Access Compliance Report
Public Rights-of-Way
(Curb Ramps)

Intersection ID: 47819 | **Main Street:** JAMES_RD | **Cross Street:** ROCKMOOR_RIDGE_RD | **Location:** NW

ADA ID: 977EBA825C41 | **Ramp Type:** Perp | **Initial Pass/Fail:** Fail | **Overall Compliance:** No | **Severity Score:** 21.25

Codes/Mitigation Info/Possible Solution

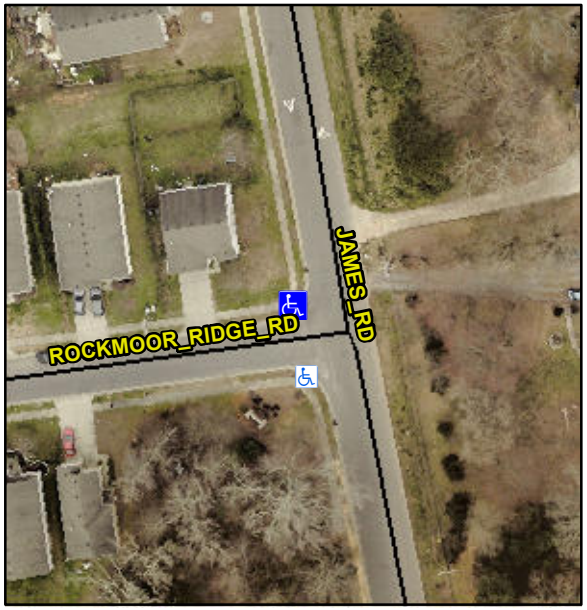
Not Found, R304.5.1, R304.2.2

Remove & Replace Entire Ramp.

Field Measurements/Component Compliance

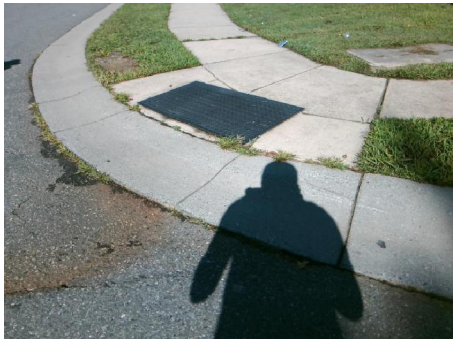
Compliance	Description	Data	Compliance	Description	Data
N/A	Ramp Length (in)	29.0	No	Ramp Slope (%)	10.1
No	Ramp Width (in)	47.0	Yes	Ramp XSlope (%)	0.2
N/A	Flare Type LT	N/A	N/A	Flare Type RT	N/A
N/A	Flare Slope LT (%)	N/A	N/A	Flare Slope RT (%)	N/A
N/A	Flare Traversable LT?	N/A	N/A	Flare Traversable RT?	N/A
N/A	Landing Length (in)	N/A	N/A	DWS Provided?	N/A
N/A	Landing Width (in)	N/A	N/A	DWS Contrast?	N/A
N/A	Landing Slope (%)	N/A	N/A	DWS Length (in)	N/A
N/A	Landing X Slope (%)	N/A	N/A	DWS Full Width?	N/A
N/A	Landing Curb? (Y/N)	N/A	N/A	DWS Offset (in)	N/A
N/A	Shared Landing?	N/A			
N/A	Gutter Ponding?	N/A	N/A	Gutter Slope (%)	N/A
N/A	Gutter Lip Ht (in)	1.0	N/A	Gutter X Slope (%)	N/A
N/A	Painted X Walk1?	No	N/A	Painted X Walk2?	N/A
	X Walk 1 Direction	To S		X Walk 2 Direction	N/A
N/A	X Walk 1 Width (in)	N/A	N/A	X Walk 2 Width (in)	N/A
	X Walk 1 Slope (%)	0.9		X Walk 2 Slope (%)	N/A

X Walk 1 X Slope (%)	2.9		X Walk 2 X Slope (%)	N/A
N/A	Ramp inside XWalk1?	N/A	N/A	Ramp inside XWalk2?	N/A
	Road Slope (%)	N/A	N/A	Clear Space?	N/A
	Road X Slope (%)	N/A	N/A	Clear Space to XWalk (in)	N/A
N/A	Any Obstructions?	N/A	N/A	Storm Grate/Utility Hazard?	N/A
	Obstruction Type			Storm Grate/Utility Type	
		N/A			N/A
			Yes	Surface Condition? (G/P)	Good
